## Accessibility Design Review Report

**Project Title:** Greenwich Hospital Redevelopment  
River Road, Greenwich

**Job Number:** 20495

**Report Version:** 20495\_ADR\_SSDA\_v1.3

**7.5 Grates**

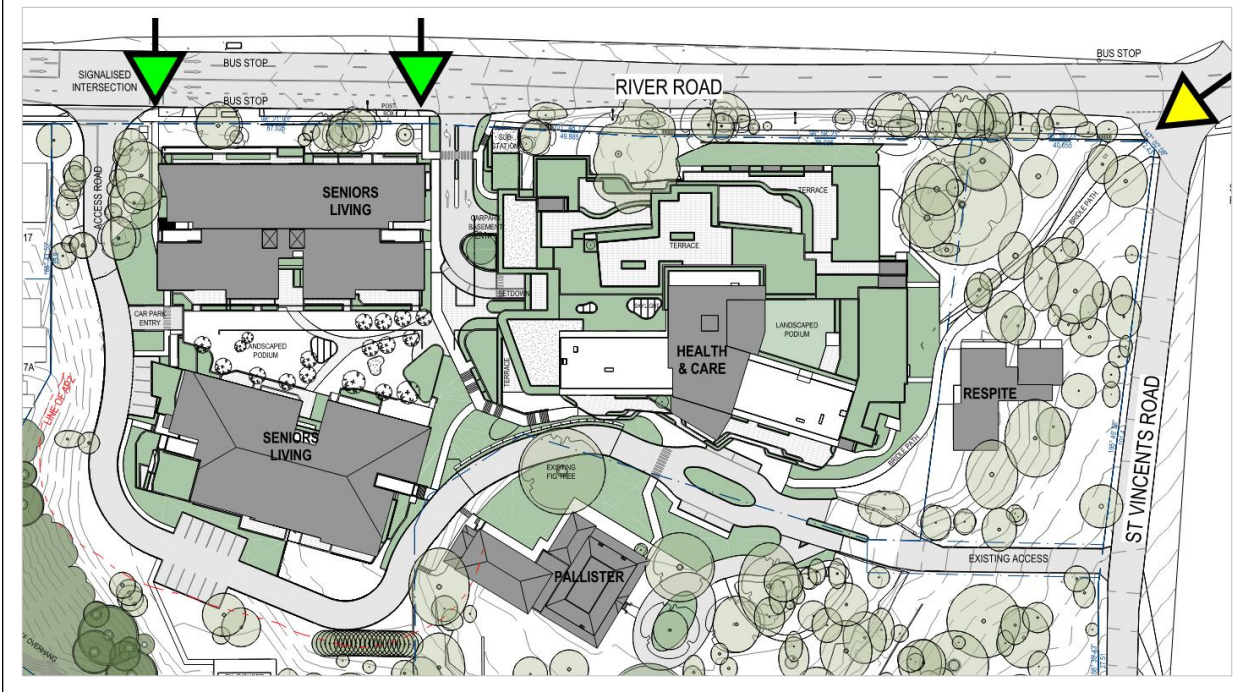
Ensure any tracks/grooves (including for water shedding or sliding doors) and grate slots/holes are no greater than 13mm wide (depending on orientation) and are recessed to maintain flush/level pathways.

<p><i>Grates shall comply with the following:</i></p> <p><i>(a) Circular openings shall be not greater than 13 mm in diameter.</i></p> <p><i>(b) Slotted openings shall be not greater than 13 mm wide and be oriented so that the long dimension is transverse to the dominant direction of travel.</i></p> <p><i>NOTE: Where slotted openings are less than 8 mm, the length of the slots may continue across the width of paths of travel.</i></p>	
--	---	--

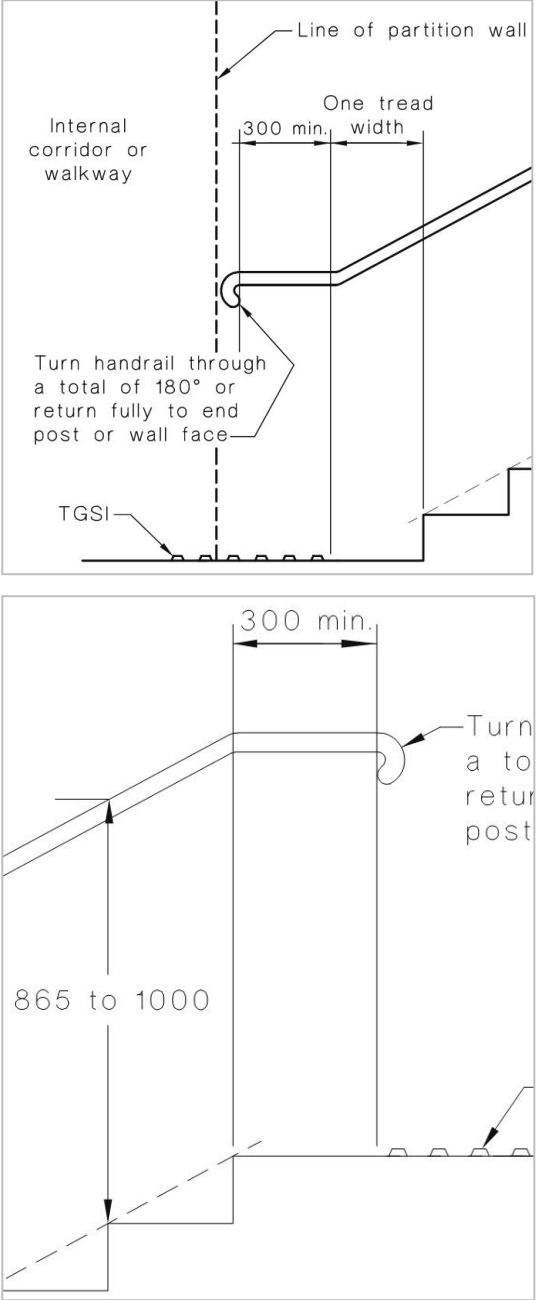
Access to the Respite building is proposed via the H&C building.

Compliance is readily achievable with minor design development and/or specification to BCA & AS1428.1-2009 at the Detailed Design Stage.
